4.0 Area C

4.11 Permitted Planning Scheme - Ground Floor

Revised Scheme -**Ground Floor**

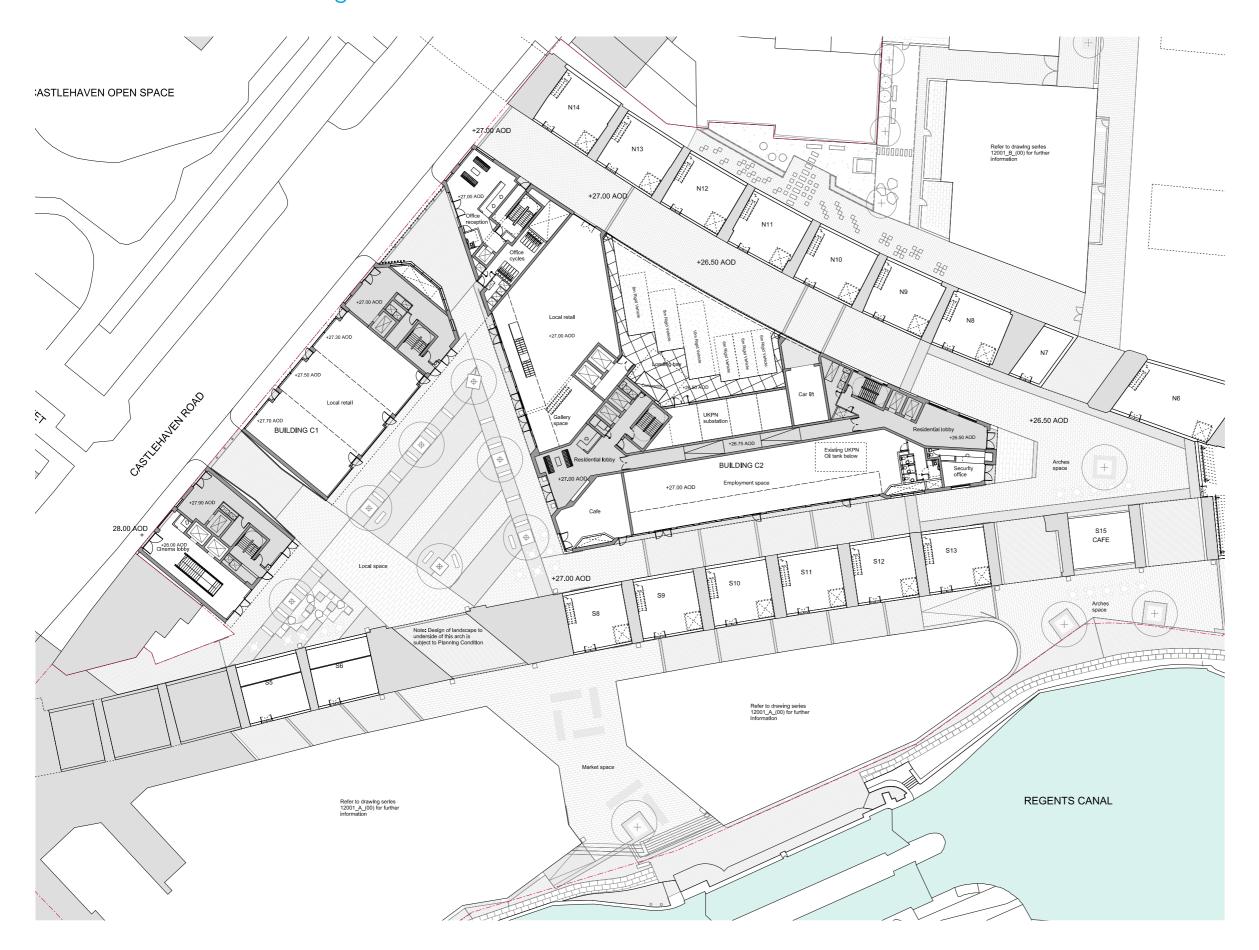
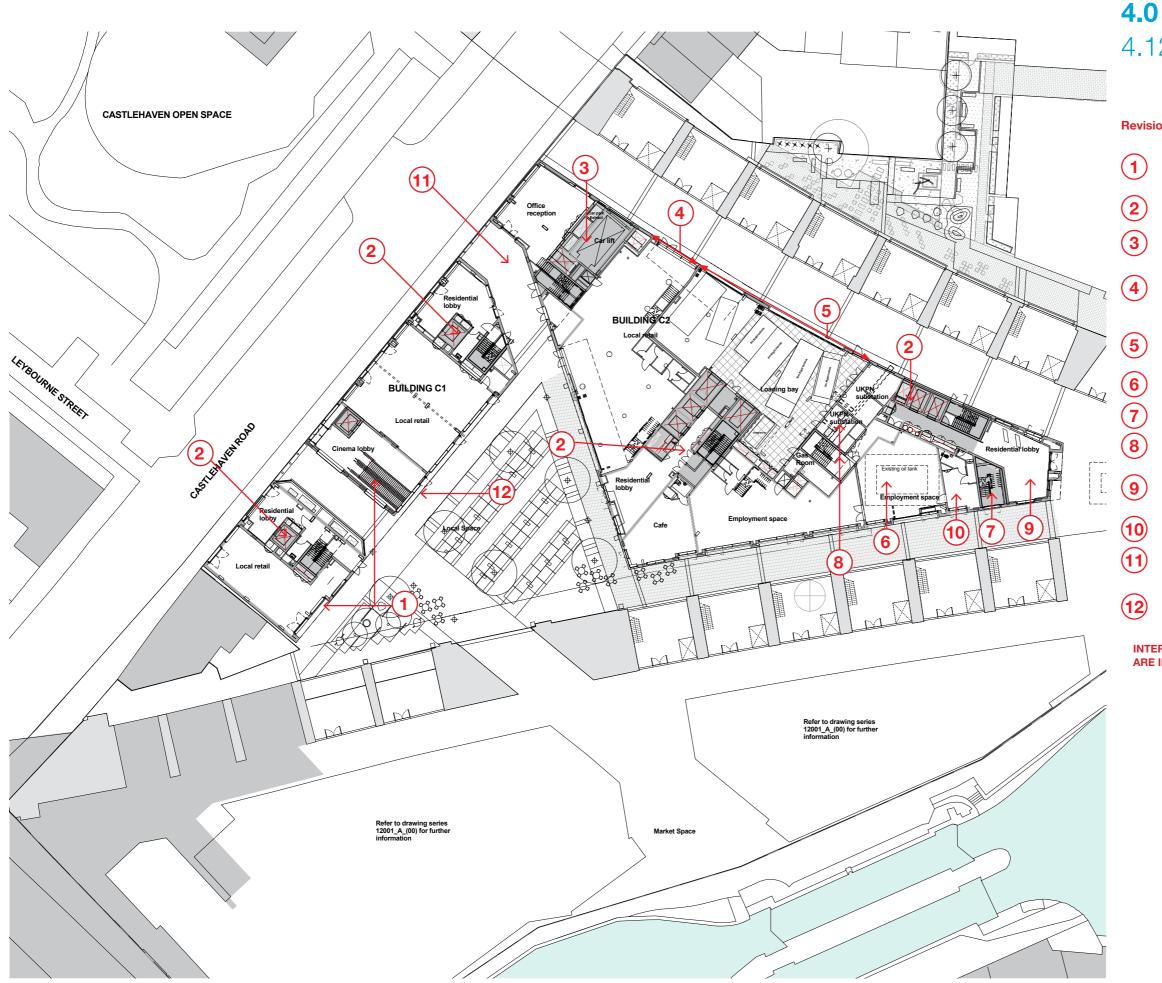
- Cinema entrance relocated due to structural constraints and detail design requirements
- Core layout revised to meet vertical transportation strategy
- Car park & car lift relocated to improve access and improve elevation efficiency

- Retail frontage increased in width and rationalised to provide better amenity for the retail unit as requested under planning condition 35
- (5)Loading bay reconfigured to meet core circulation requirements and reduce flame spread to adjacent arches

- Zone for oil tank revised for UKPN following detailed design
- Additional stair required for office fire escape
- (8) Substation and gas plant room revised to meet UKPN & MEP detail design requirements

- Residential lobby revised and rationalised to suit internal improvements to design
- (10) Security office relocated
- Cut through design changed to rationalise relationship with bays

- Step back to retail units maintained but reduced slightly to meet facade thermal performance requirements
